Service Letter No. 369

SUBJECT: Inspection of Brake Cable and Pulleys

MODELS AFFECTED: PA-22-150 Tri-Pacers - Serials 22-3218, 22-3387 and up
PA-22-108 Colts - Serials 22-8000 and up

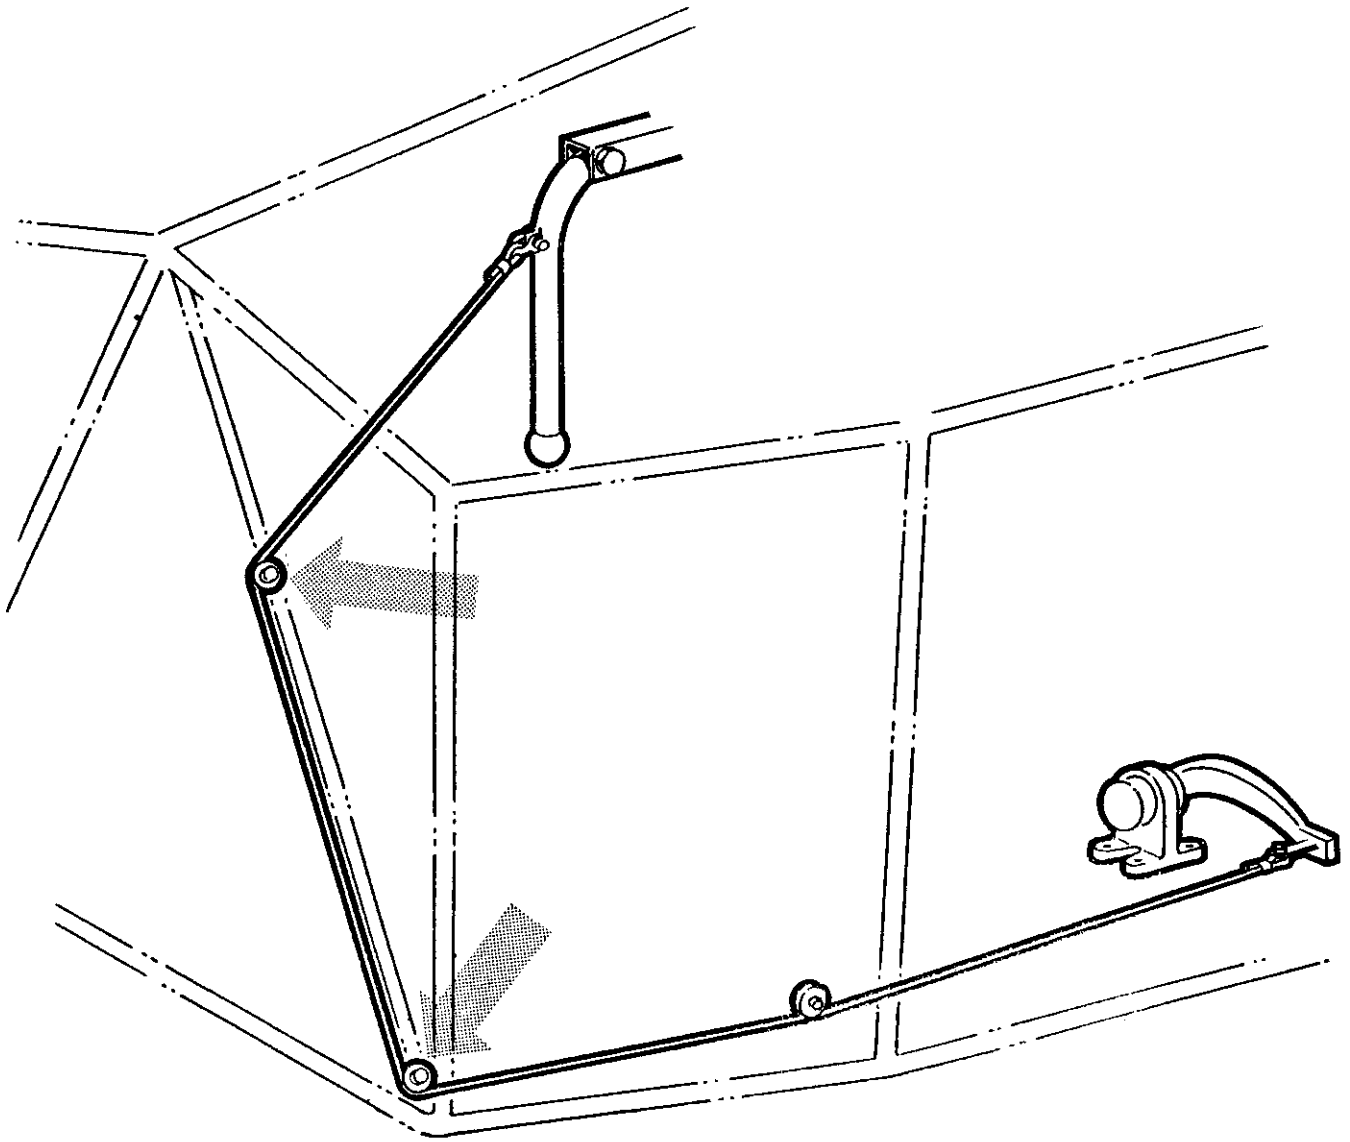
Service experience would tend to indicate that a closer inspection of the brake cable and pulleys is necessary in the subject aircraft. A number of reports of frayed or broken cables, generally where the cable contacts the pulleys, have been received.

It is suggested that an immediate inspection be made of the general areas indicated on the sketch on the reverse side of this letter. This area should be included in all subsequent routine inspections.

Inspect brake cable where indicated
